- 1. Lower Cohoe Subdivision Tracts 1-7; KPB File 2022-057
R&M Consultants / Alaska Mental Health Trust Authority
Location: Herrin Street, Fairway Avenue & Cohoe Lake Road
Cohoe Area**

PRELIMINARY PLAT OF LOWER COCHO SUBDIVISION TRACTS 1 THRU 7

ITEM 1 - LOWER COHOE SUBDIVISION TRACTS 1 THRU 7

STAFF REPORT

Vicinity Map

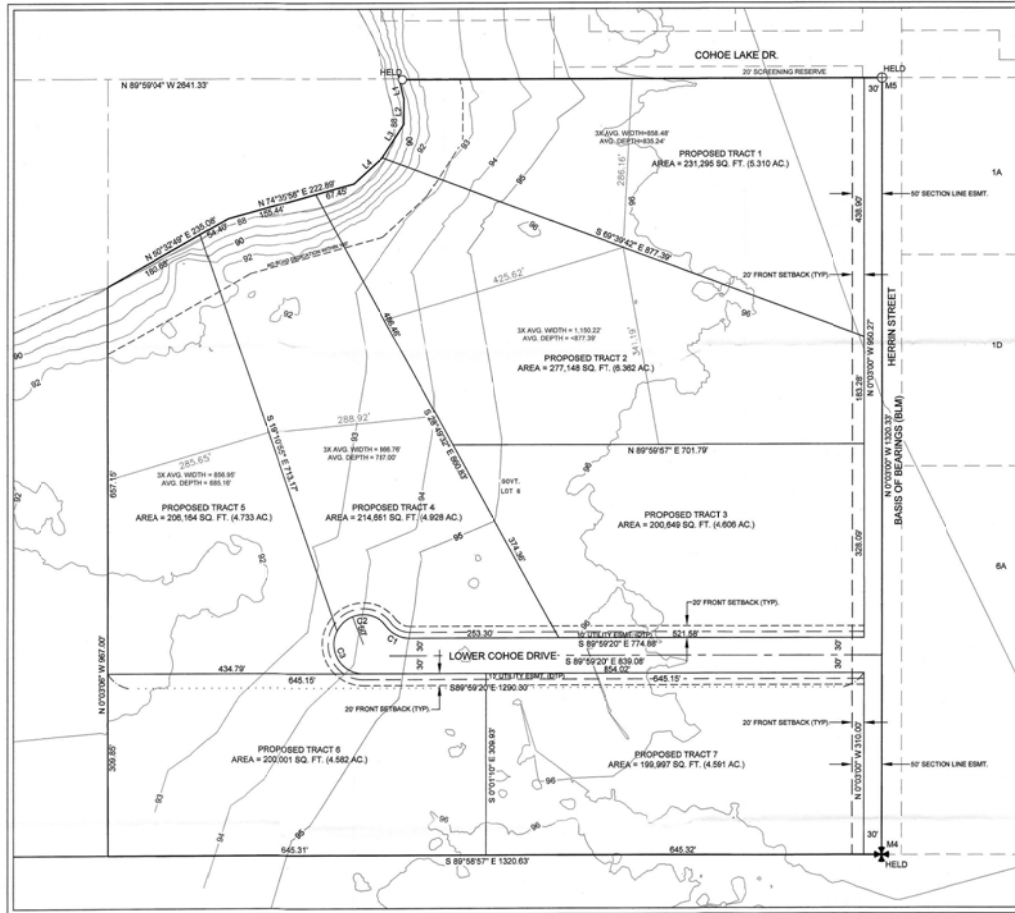
- D. A vicinity map, drawn to scale showing location of proposed subdivision, north arrow if different from plat orientation, township and range, section lines, roads, political boundaries, and prominent natural and manmade features, such as shorelines or streams;
Staff recommendation: *Map meets all criteria but the sections shown can be reduced to make the map smaller to improve spacing on the plat. A 3 x 3, 3 x 4, or 4 x 4, depiction with subject section being near center will be sufficient.*

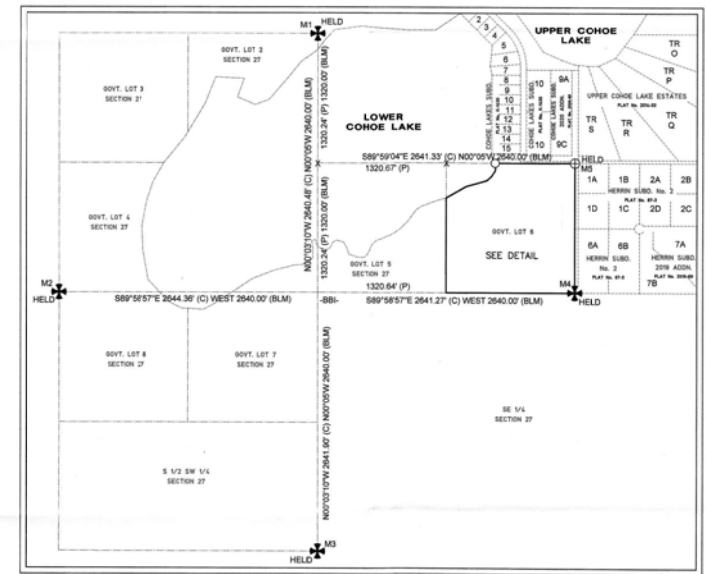
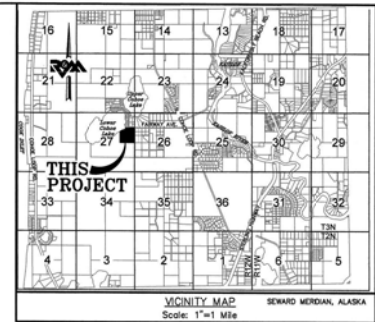
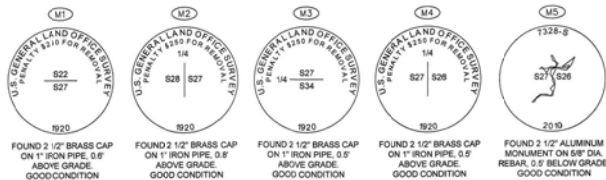
The setback should be labeled and depicted along Fairway Avenue.

- *The owner should match the deeds and certificate to plat, which is Alaska Mental Health Trust Authority.*
- *Update the location description to make "Sections" singular as it is only within one section.*
- *The KPB File number will need to be included within or near the title block.*
- *Staff suggests the name be shortened to Lower Cohoe Subdivision. In smaller text below the name you can add "Creating Tracts 1 Thru 7" if desired.*

- *Update the label of Cohoe Lake Drive to Fairway Avenue. Cohoe Lake Drive is the north-south right-of-way located at the end of Fairway Avenue.*
- *Provide a label for Cohoe Lake Drive.*
- *Provide a label for Herrin Circle.*
- *Provide right of way width labels for Cohoe Lake Drive, Fairway Avenue, Herrin Street, and Herrin Circle.*

- *A new dedication is proposed as Lower Cohoe Drive. Cohoe is on the street name prohibited list. The suffix should also be Court as defined by KPB code.*

- *A 30 foot wide dedication for Herrin Street is proposed.*
 - *Both rights-of-way will require a label stating "Dedicated by this Plat".*
- G. The status of adjacent lands within 100 feet of the proposed subdivision boundary or the land status across from any dedicated rights-of-way that adjoin the proposed subdivision boundary, including names of subdivisions, lot lines, block numbers, lot numbers, rights-of-way; or an indication that the adjacent land is not subdivided;
Staff recommendation:

- *Include the name of the lake.*
 - *Add a Government Lot 5 label to the lot to the west.*
 - *Provide an "Unsubdivided" label for the land to the south.*

- *Within the enlargement area, Lot 9C north of the subdivision, is incorrectly depicted as well as the depiction of Herrin Circle. Update the lot depiction to configuration at the time of final.*

Staff recommendation: *Meander source is required to be sited or provide a year label for the data if measured or computed as part of this plat. Comply with 20.60.110.*

Staff recommendation: *Correct the line along the southwest located outside the boundary to be the same depiction of neighboring lot lines.*
